DEPARTMENT OF HIGHWAYS ONTARIO BRIDGE DIVISION			
HIGHWAY # 2 UNDERPASS 1 MILE EAST OF DUFF'S CORNERS			
KING'S HIGHWAY No. 2 E 403		DIST. No. 4	
CO. WENTWORTH		TWP. ANCASTER LOT 38 CON. III	
PRELIMINARY PLAN			
APPROVED _____ BRIDGE ENGINEER		SITE No. _____ W.P. No. 194-61	
DESIGN A.R.B. DRAWING S.M. DATE NOV 62	CHECK H.H. CHECK H.H. LOADING H-20 5-16	CONTRACT No. _____ DRAWING No. D-5149-P1	_____

Foundation Report No. 62-F-100
Hwy. No. 2, Lin: A & Hwy. No. 403
Line 'B' Ext. W.P. 194-61
District No. 4, Hamilton.

D.H.O. FOUNDATION INVESTIGATION
REPORT
W.J. 62-F-100 -- W.P. 194-61.

Hwy. #2 Interchange 1 Mile East of
Duff's Corners - Hwy. 403.
W.P. 194-61 -- W.J. 62-F-100
District #4.

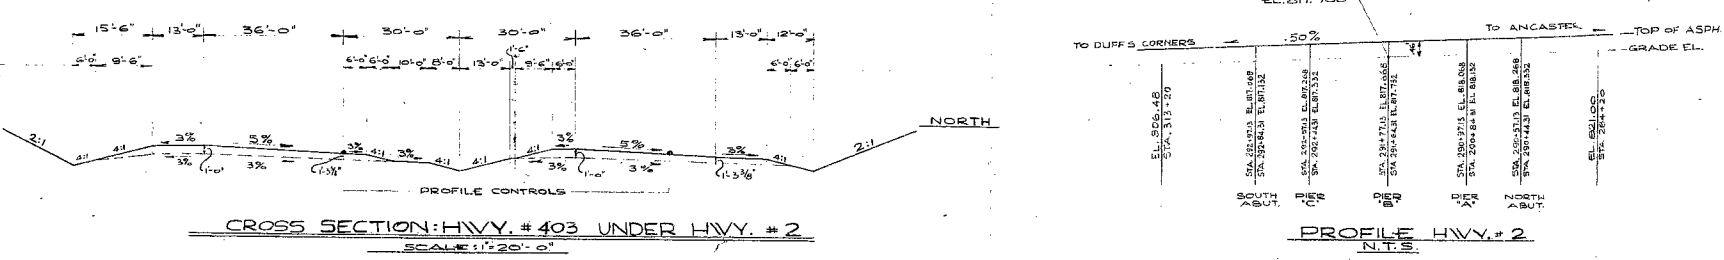
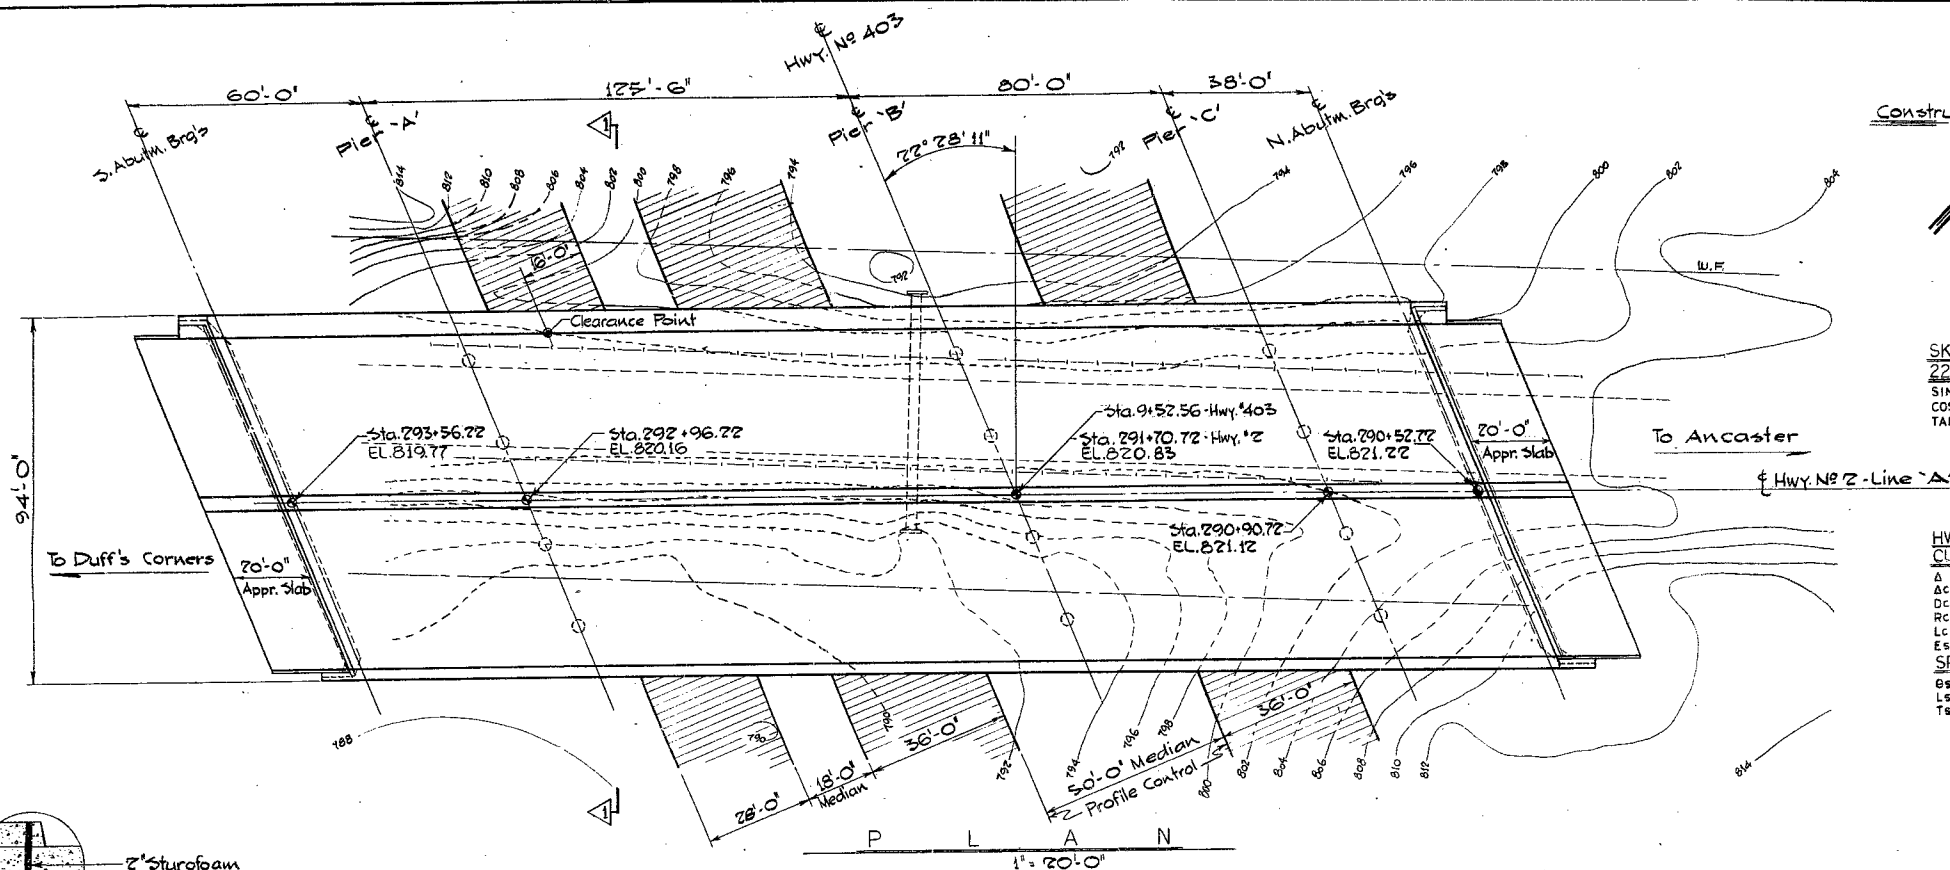
We are sending attached one print D 5149-1 for your review.

The designer is using 12" diameter tube piles carrying 40 tons and driven to tip elevation of 775 as per soil report recommendation. Since Hwy. 403 is in a cut here this leaves piles at the piers with a length of only nine feet. If the piles are a combination of friction and end bearing they may not be able to develop this load in such a short length.

The Foundation Report (62-F-100) recommends that pile driving be controlled in the field by means of the Hiley Formula and estimates that a design load of 40 tons/pile will be achieved at or about el. 775.0 if 12 $\frac{1}{2}$ " O.D. steel tubes are used. In view of the fact that the pier foundations for the structure will be located in a cut, the exact depth of which was not known at the time of preparation of the report, it is our further recommendation that piles be driven to at least 15' below the footing bases, even if the dynamic formula indicates that the required capacity has been attained at a higher elevation.

DESIGN A.R. CHECK _____ CONTRACT No. _____
 DRAWING T.T.B. CHECK _____ DRAWING No. D-5771-P1
 DATE Sept. '65 LOADING H20-S16

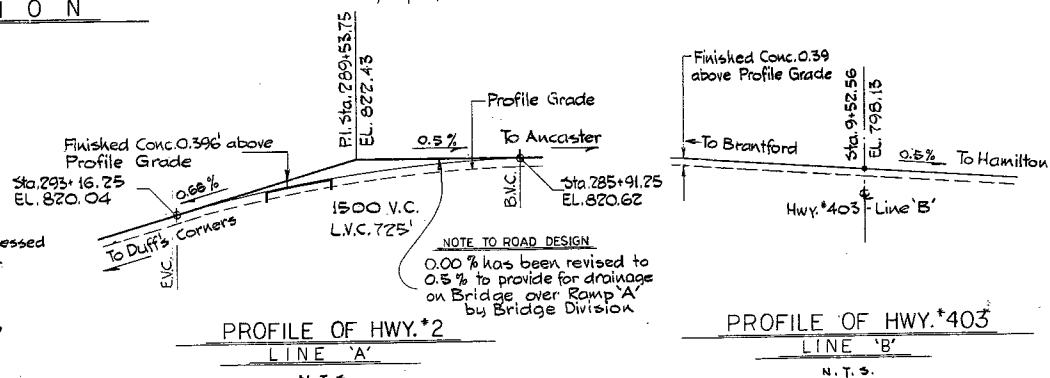
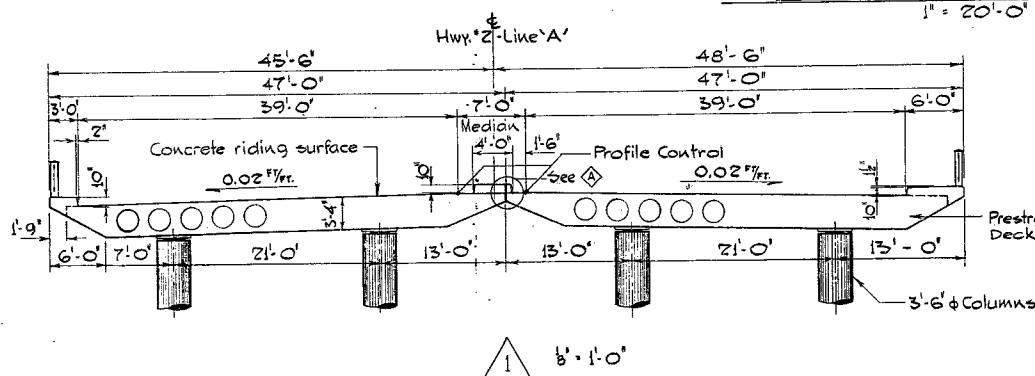
We have reviewed the preliminary bridge plans for the above-mentioned projects and submit the following comments:

The piles for the pier footings should be driven at least 15 ft. below the footing bases, even if the dynamic formula indicates that the required capacity has been attained at a higher elevation. This information should be given on the Contract drawings.
